Regarding: Wang Residence
Lot 39
StillWater Subdivision
Still Beach Court
Sacramento, CA
APN# 031-1350-019

Framing Filed Inspection Comments:

PROJECT: Wang Residence
41 Still Beach Court
Sacramento, CA 95831

SUBJECT: City Inspection Comment

TYPICAL TOP PLATES REPAIR

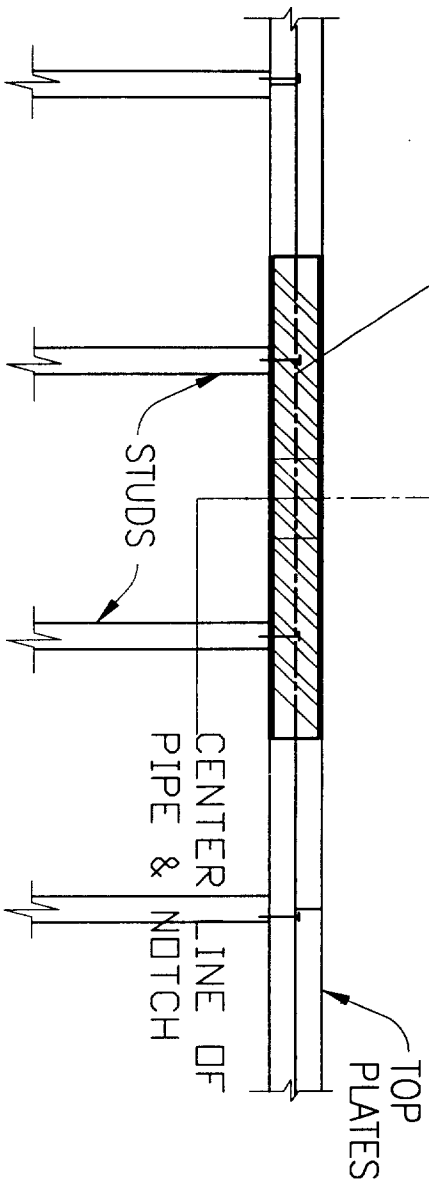
ADD 2 - SIMPSON RPS28 STRAP OVER THE NOTCH
 LOCATE THE STRAP SYMMETRICAL WITH
 RESPECT TO PIPE CENTER LINE
